1995 - 1996 Corvette: Service Bulletin: Delayed Engagement (Replace Pump Cover Assembly)

Subject: Delayed Engagement (Replace Pump Cover Assembly)

Bulletin Number: 67-71-48

FIGURE 1. - HYDRA-MATIC 4L60-E TRANSMISSION IDENTIFICATION INFORMATION

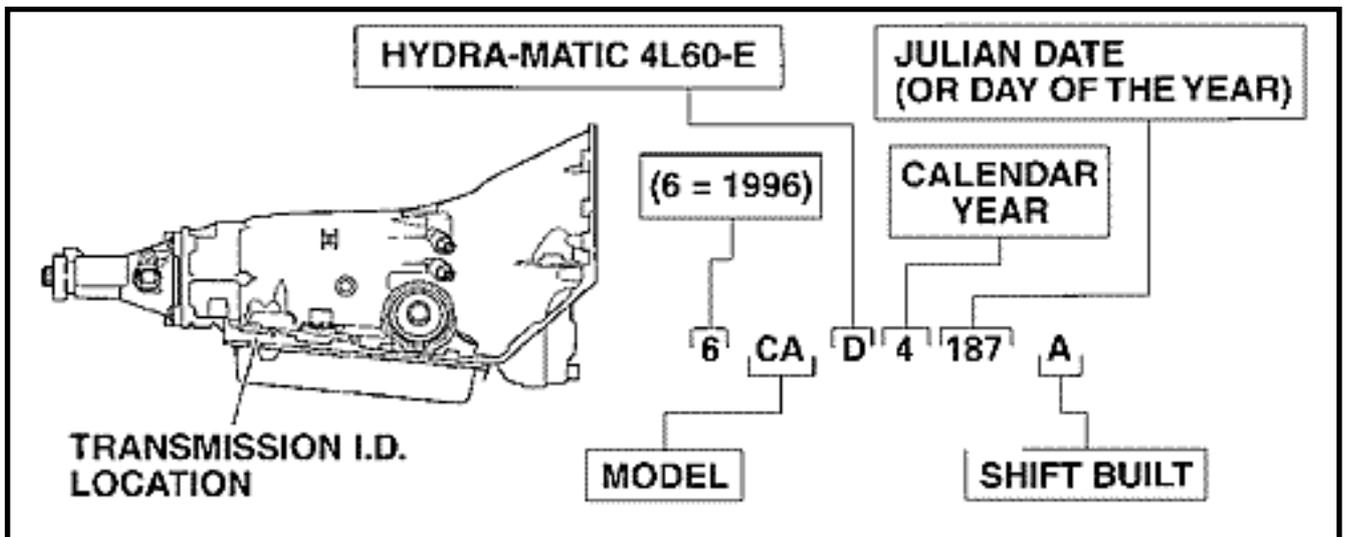
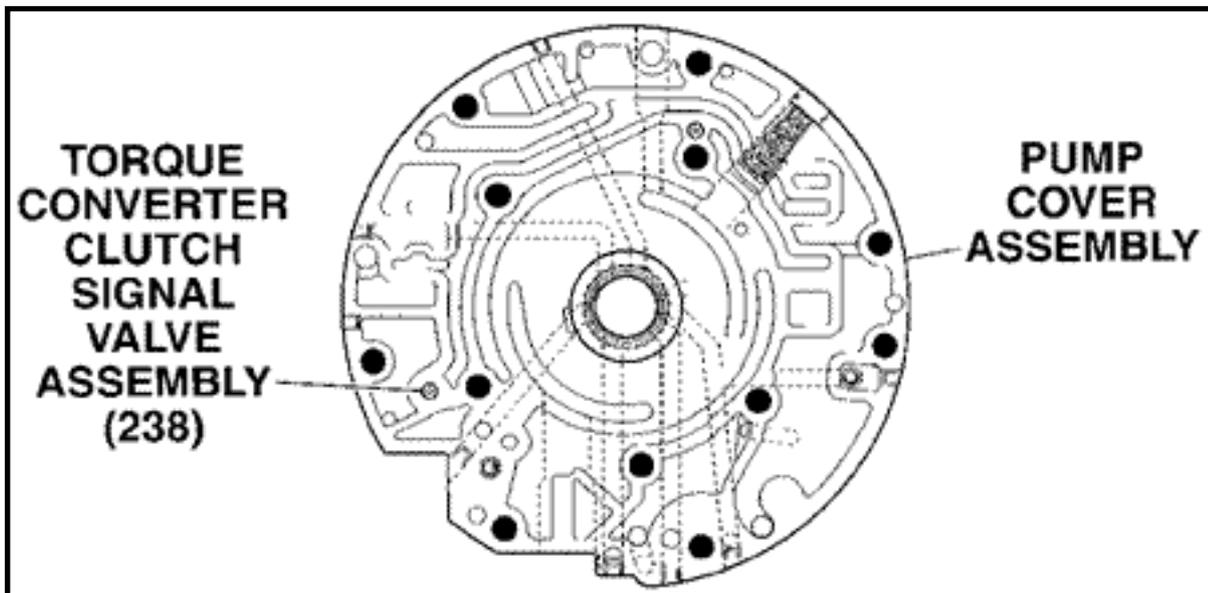
(FIGURES 1 AND 2) SOME OWNERS OF THE ABOVE MODELS, WITH A HYDRA-MATIC 4L60-E TRANSMISSION (BUILT BEFORE APRIL 29, 1996/JULIAN DATE 6120), MAY EXPERIENCE SOME DELAYED ENGAGEMENT WHEN VEHICLE IS NOT USED FOR MORE THAN 48 HOURS.

FIGURE 3. - TORQUE CONVERTER CLUTCH SIGNAL VALVE ASSEMBLY LOCATION

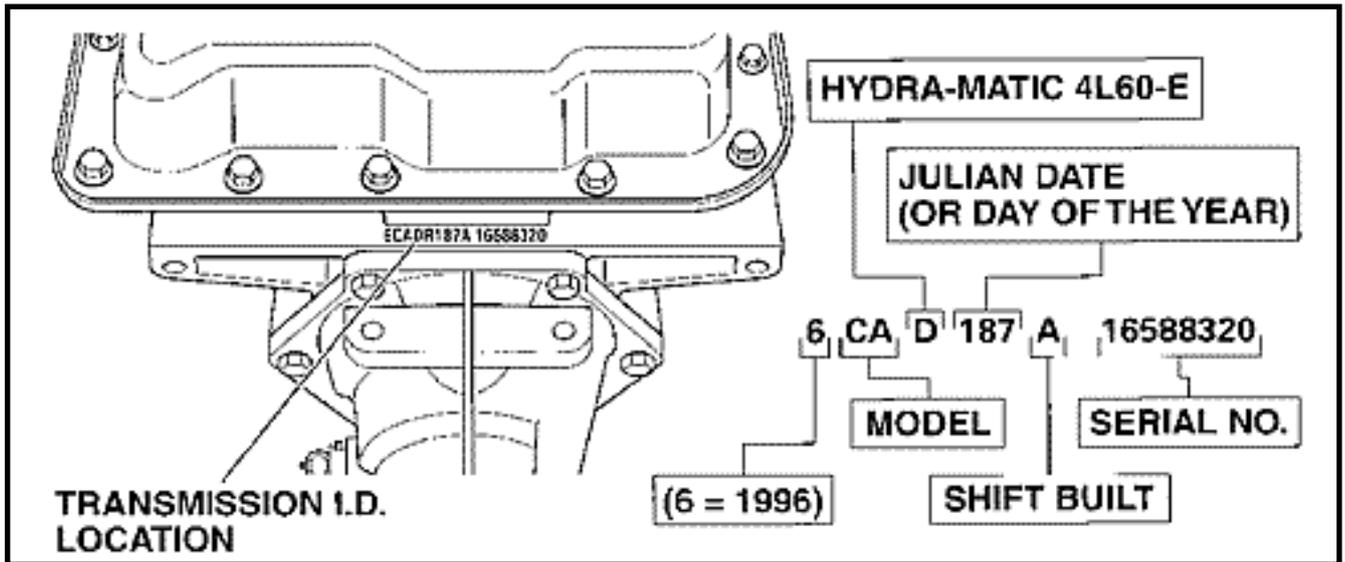
TORQUE CONVERTER FLUID LEVEL LOW DUE TO FLUID DRAIN DOWN.

(FIGURE 3) REPLACE PUMP COVER ASSEMBLY WITH THE NEW TCC SIGNAL VALVE ASSEMBLY.
